NUREG-1437, Supplement 38,
Vol. 3

Generic Environmental Impact Statement for License Renewal of Nuclear Plants

Regarding Indian Point Nuclear Generating Unit Nos. 2 and 3

Final Report Public Comments Continued, Appendices

Figure 2: The standardised juvenile index for white catfish in the Hudson, showing a decreasing trend through time. The trend is significant ($a = -0.0136$, $b = 27.216$, $F = 14.0414$, $p = 0.0008$) (Seaby and Henderson, 2007)

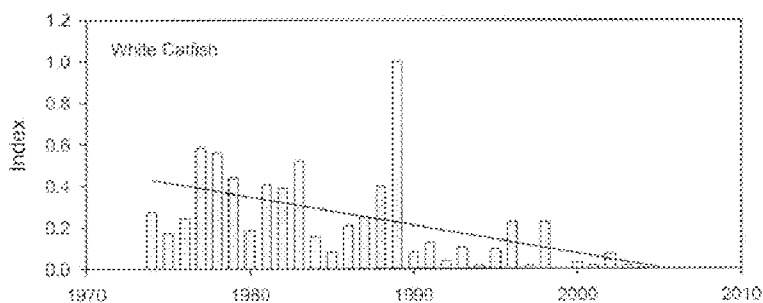
The Year Class Reports for the Hudson River Estuary Monitoring Program shows that, river-wide, juvenile white catfish have been in a steep decline in abundance since 1990 (Figure 2).

It is therefore unsurprising that in Table 4-4 (see Figure 1) the population line of evidence is for a 'Large' potential adverse impact. The trend shown in Figure 2, which is statistically significant, certainly seems to correspond with the definition of Large given on page H-33, NUREG-1437, Vol 2:

Figure 3: The standardized juvenile index for weakfish in the Hudson showing a decreasing trend through time. The trend is significant ($a = -0.0155$, $b = 31.0218$, $f = 7.0811$, $p = 0.0134$) (Seaby and Henderson, 2007)

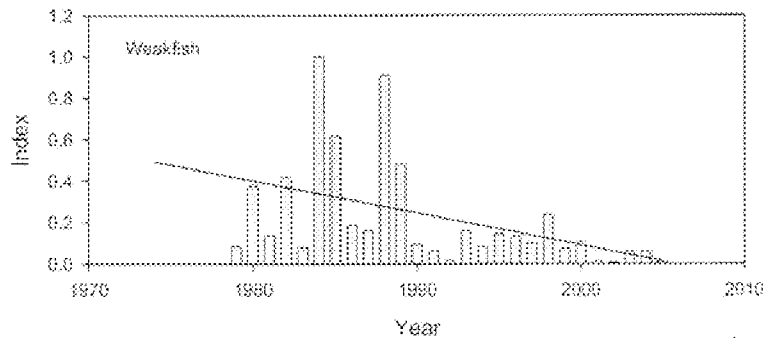
Like white catfish, weakfish have also shown river-wide a steep decline in abundance since 1930 (Figure 3). However, unlike white catfish, for this species Table 4-4 classifies the population line of evidence as "Small".

A 'Small' potential for adverse impact is defined on page H-32 vol 2 as:

Figure 5: The standardized juvenile index for rainbow smelt in the Hudson.

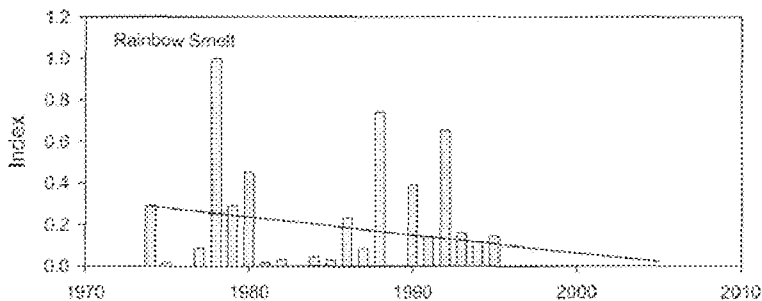
Juvenile rainbow smelt have disappeared from the survey since the mid 1990s (Figure 5), and it is therefore unsurprising that Table 4-4 assesses the population line of evidence as 'Large'. However, the impact of Indian Point 2 and 3 is assessed as moderate because the strength of connection is assessed as 'Medium'.

Examination of Table 1-32 (Figure 4) shows why the overall impact is only 'Moderate'. This table shows that both the impingement and entrainment of rainbow smelt has been appreciable, and entrainment has been given the highest score possible of 4. However, the strength of connection is only medium because both the impingement and entrainment prey scores are 1. The reason for this is stated in NUREG-1437, Vol. 2 page 1-41.

Figure 6: The standardised juvenile index for tomcod in the Hudson showing a decreasing trend through time. [Seaby and Henderson, 2007]

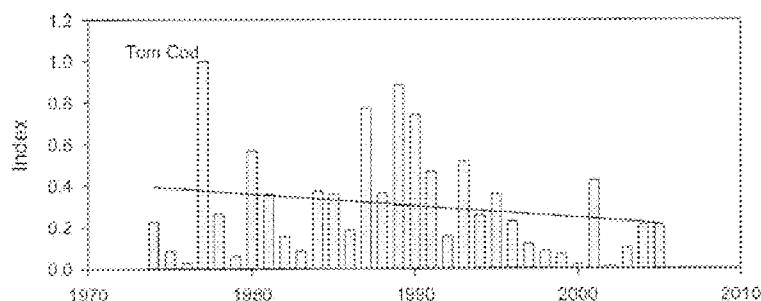
Examination of Table 1-32 (Figure 4) shows that a number of the RIS species have a prey score for impingement and entrainment of 1, and thus are unlikely to score highly for the strength of connection. This feature of the scoring protocol is thus central to the final outcome. The Atlantic tomcod makes a telling further example. The tomcod population shows considerable year-to-year variation, but appears to be in long-term decline (Figure 6). The average standardised index from 1975 until 1995 is 0.156; in comparison the index for the last ten years of sampling (1996-2005) is only 0.0617. In the last 10 years, only 2001 produced a good recruitment, although there are signs of a recent slight improvement in tomcod numbers.

While the population line of evidence for a decline is large, the invertebrate prey of this species is primarily responsible for the low-to medium strength of connection and the final conclusion that the impact is small to moderate.
